LOWER MINNESOTA RIVER WATERSHED DISTRICT

Item 6. C. - CenterPoint Energy (CPE) Xenwood Avenue and West 125th Street (LMRWD No. 2024-018)

Technical Memorandum

Re: CenterPoint Energy (CPE) Xenwood Avenue and West 125th Street (LMRWD No. 2024-018)

Figure 2: Site Plan
Xenwood Ave & 125 St W Project (WO# 113233080)
 CenterPoint Energy
 Savage, Scott County, Minnesota

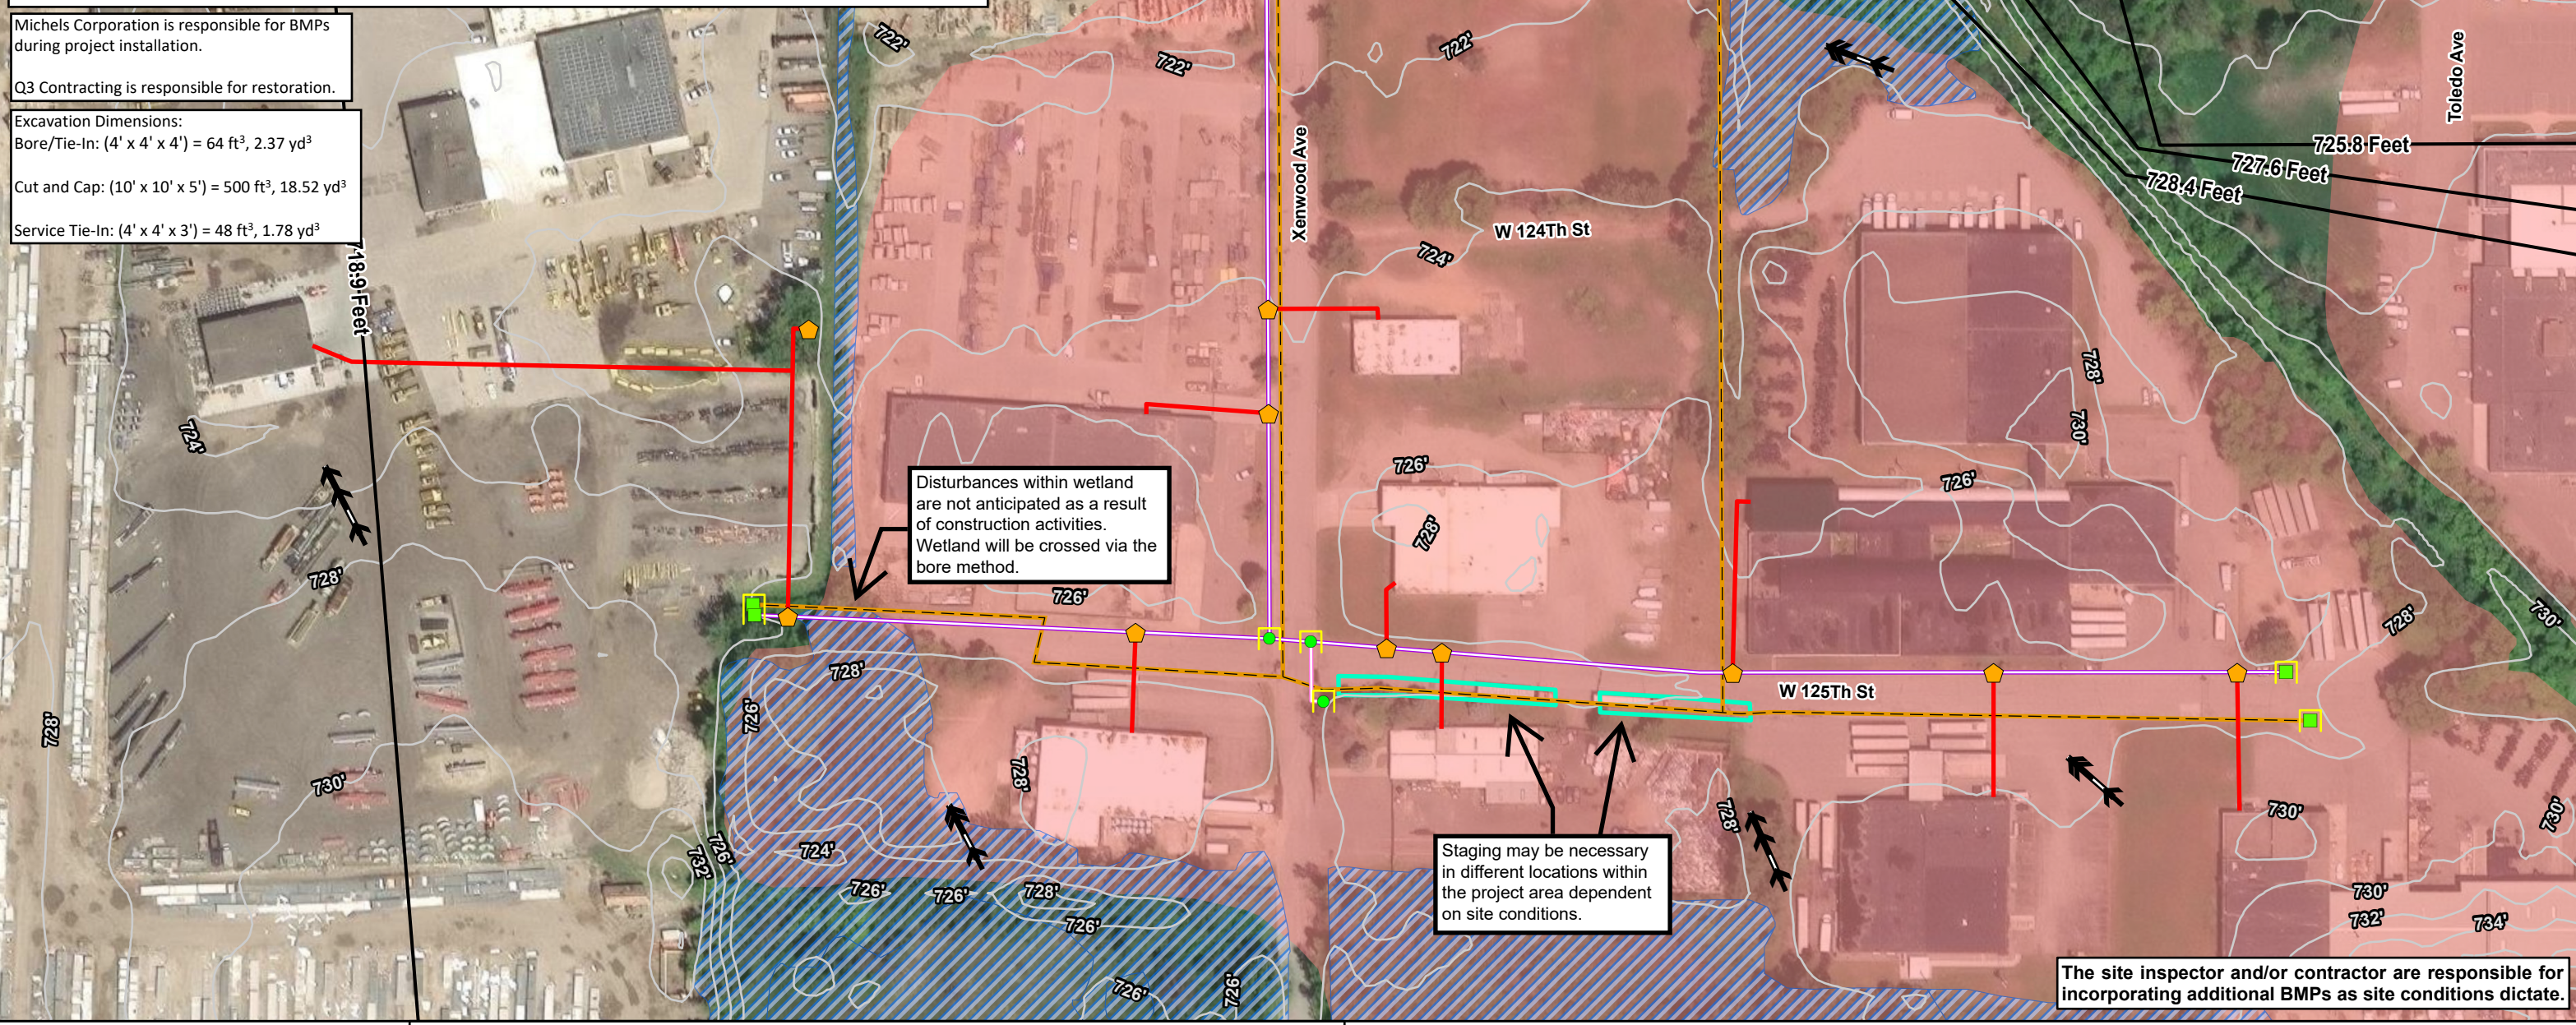
These excavations total 102 cubic yards of excavation and fill and 624 square feet of temporary soil disturbance. All bore and tie-in locations are located within the City road right-of-way, and documentation of approval from the City of Savage will be required as a conditional approval item. All disturbed areas will be restored to existing conditions, including revegetation. Because no permanent alterations will be made to ground elevations in the floodplain, modeling and a no-rise certificate were not required.

The applicant submitted erosion and sediment control plans. Temporary BMPs proposed include silt fence, mulch, and seed for disturbed areas. The applicant provided contact information for the contractors undertaking land disturbing activities as part of the proposed project:

The project generally complies with Rule C; however, contact information for the person responsible for inspection and maintenance of all erosion and sediment control features is required before the LMRWD can issue a permit.

- Contact information for the person responsible for construction and maintenance of erosion and sediment control measures.
- Documentation of approval from the City of Savage for work in the road right-of-way
